***Project: PGT Connector Building***  
**Site and Development Plan Petition No. 17-04SP**  
**Special Exception Petition No. 17-07SE**

**Staff Report**

**FIGURE 1: Master Site Plan Drawing**

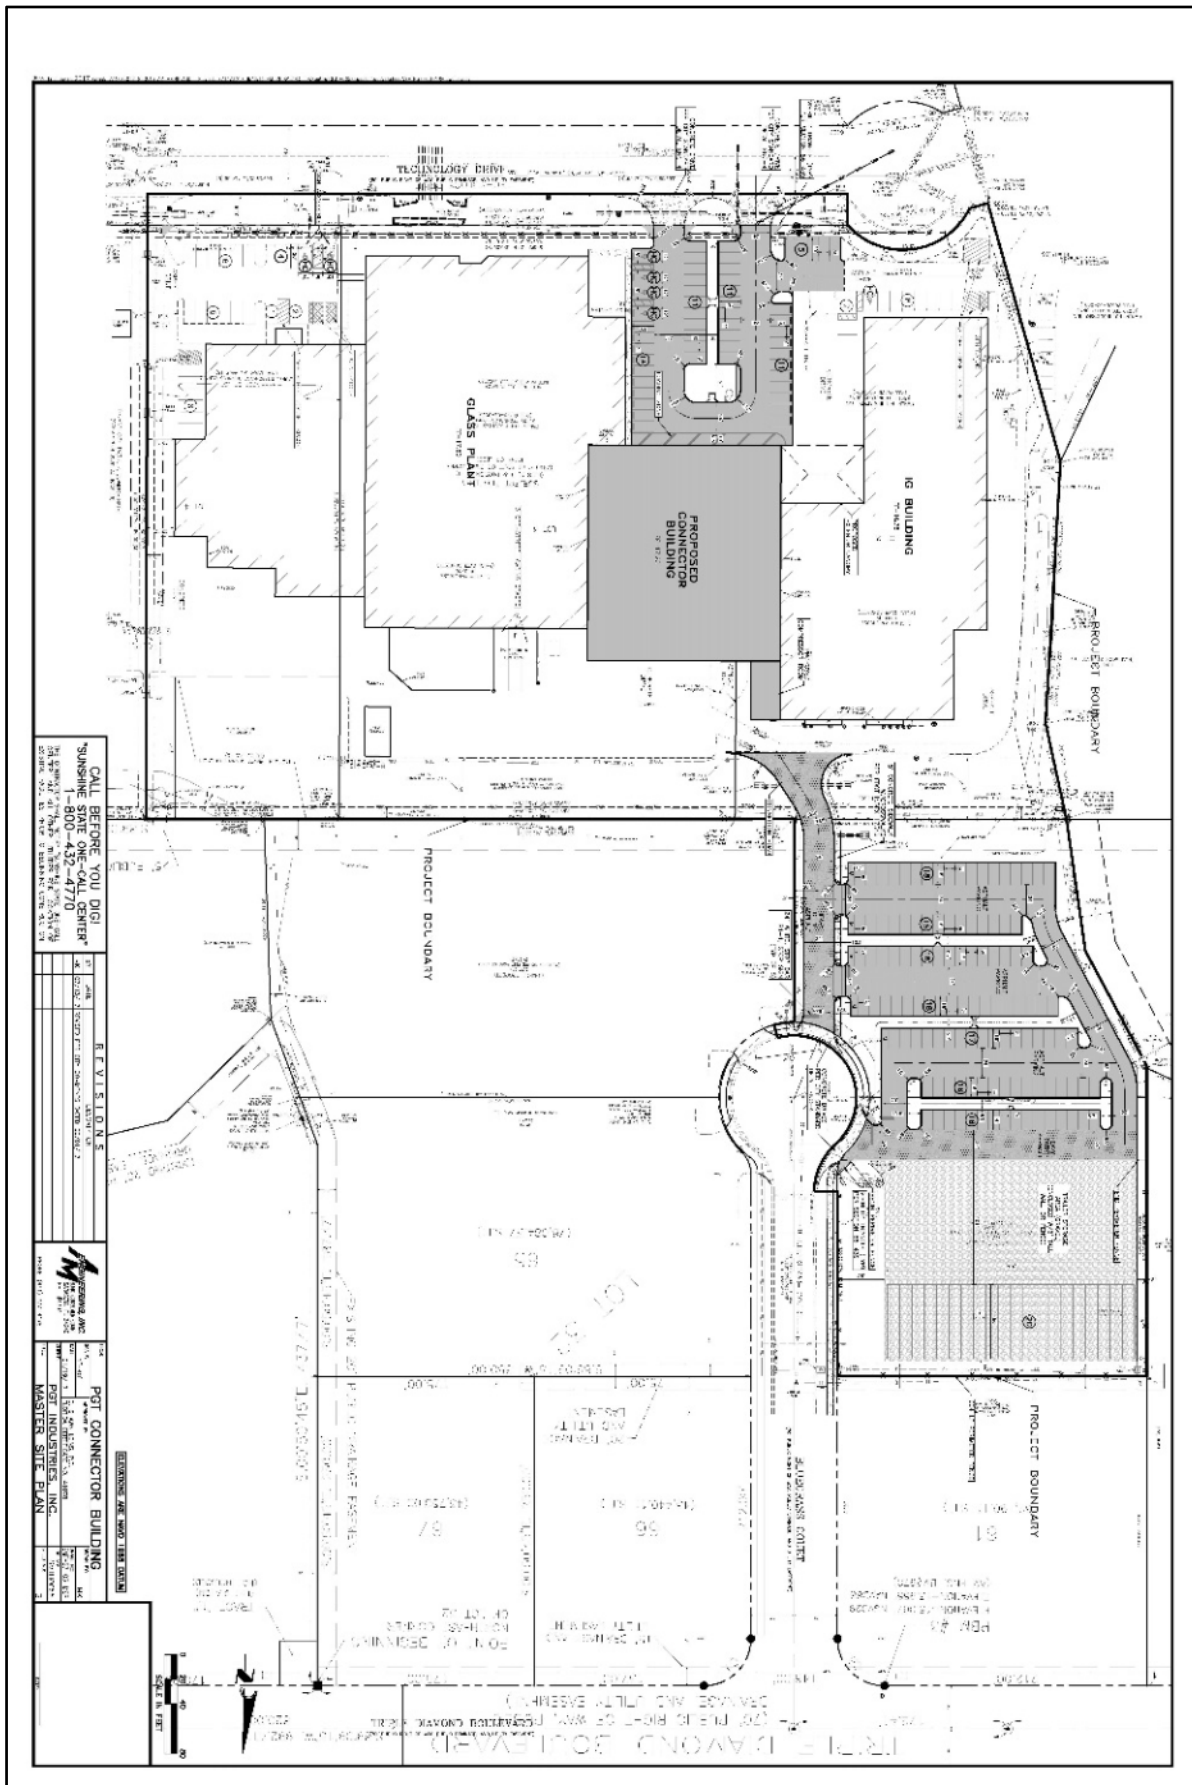
Approval of the site and development plan as currently designed requires special exception approval of modifications from the following Land Development Code standards:

- Section 86-132(h)(4)a to reduce the minimum setback for structures or activities from 25 feet from a PID boundary to zero feet to allow a driveway which will connect PGT-owned property in the Triple Diamond Commerce Plaza PID and the Laurel Interchange Business Center PID.
- Section 86-412(a) to reduce the minimum width of off-street parking spaces from ten feet to nine feet, and reduce the minimum width of one parking aisle from 24 feet to 20 feet.

**Staff Comment:** The driveway was constructed without city approval. The applicant seeks after-the-fact approval of the driveway. If approved, the driveway will be designed and constructed in compliance with the LDC.

**Staff Comment:** The 20-foot width standard cited by the applicant is for aisles with parallel parking on each side of the aisle. There is no parking along the subject drive/aisle which provides access to aisles with parking. The Fire Department did not raise a concern about the proposed drive/aisle width as it related to emergency access.
